Certificate of Appropriateness

Property 701 W. HISTORIC MITCHELL ST.
Description of work 100% repointing of building, excluding top 25% of east wall. Top of east wall awaits brick arrival. Mortar is to be Type N or O with lime inclusions, V or Grapevine jointing, and color comparable to USHeritage Oyster #1.
Date issued 11/29/2021 PTS ID 115170 COA: 100% REPOINTING

REPOINTING DETAIL

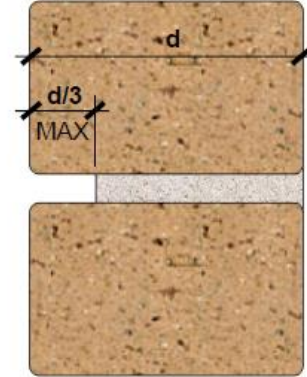
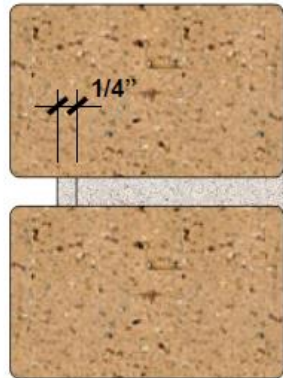
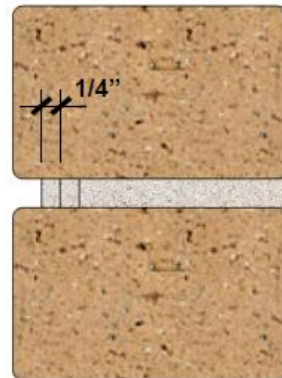
2. JOINT GROUND TO INCORRECT PROFILE

3. JOINT GROUND TO INCORRECT PROFILE

7. FINAL PASS INCORRECTLY SMEARED ABOUT BRICK EDGES RESULTS IN EXAGGERATED JOINT WIDTH

4. JOINT RAKED TO SOUND MORTAR ($d/3$ MAX.) AND GROUND TO 90° PROFILE

8. FINAL PASS TOOLED TO CONCAVE OR VEE PROFILE TO MATCH EXISTING
